SERVICE DIRECTIVE BULLETIN

SERVICE NOTE NO. 0015 Page 1 of 2

Subject: Cyclic Stick Torque Tube Assemblies

Models Affected: F-28A Serial Numbers 3 through 94; 97 through 112; 115, 119, 120, 123;

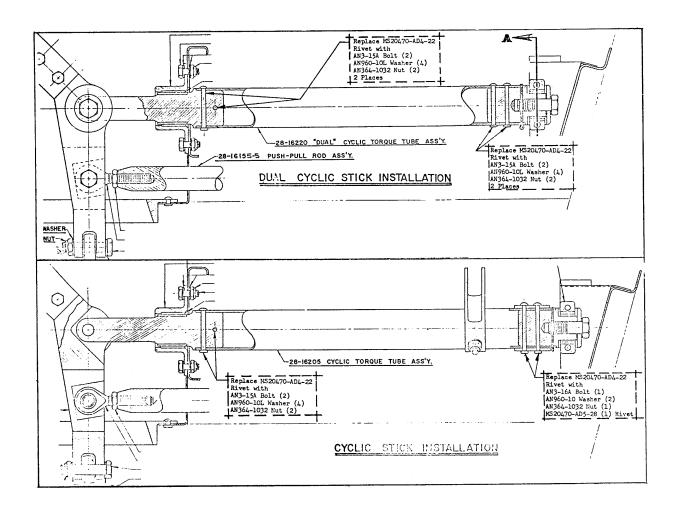
Three instances have been reported of fretting of the MS20470AD4-22 rivets on the 28-16205 cyclic torque tube assembly and the 28-16220 "dual" cyclic torque tube assembly. These four connections are illustrated on page number two of this Service Note. If any of the MS20470AD4-22 rivets are found to be loose, they should be replaced by using the hardware listed on the attached sheet.

To install the aforementioned hardware, disassemble 28-16205 and 28-16220 torque tube assemblies at the fore and aft mounting locations. Remove the torque tube assemblies from the seat structure. Drill out the existing MS20470AD4-22 rivets. Drill the existing (.125) diameter holes to (.1875) diameter and install the proper AN3 bolts. Due to the rivet spacing on the pilot's 28-16205 torque tube assembly, the aft fitting requires one AN3-16A bolt and one MS20470-AD5-28 rivet. This fitting is shown on the lower right-hand side of the attached illustration. After the proper hardware has been installed, reassemble the torque tubes in the proper location in the seat structure.

The second paragraph of Service Note 0015 explains the recommended hardware for the aft fitting on the pilot's 28-16205 torque tube assembly. We have been made aware the distance between the center of the rivets will not allow the use of an MS20470-AD5-28 rivet with an AN3-16A bolt. To rectify this situation, drill out one of the existing MS20470-AD4-28 rivets and install the AN3-16A bolt in its place. The remaining MS20470-AD4-28 rivet should be left intact. If the remaining MS20470-AD4-28 is found to be loose, it should be drilled out and replaced by a rivet of the same size.

After drilling the respective rivets out and enlarging of the holes to accept the AN3 bolts, install the correct hardware on the aft fittings of the 28-16205 and 28-16220 torque tube assemblies. Insert the respective torque tube assemblies back into the seat structure to their proper locations. At this time install the correct hardware to the forward fittings. If this procedure is not followed, extreme difficulty will be incurred when reinserting the torque tubes back into the seat structure.
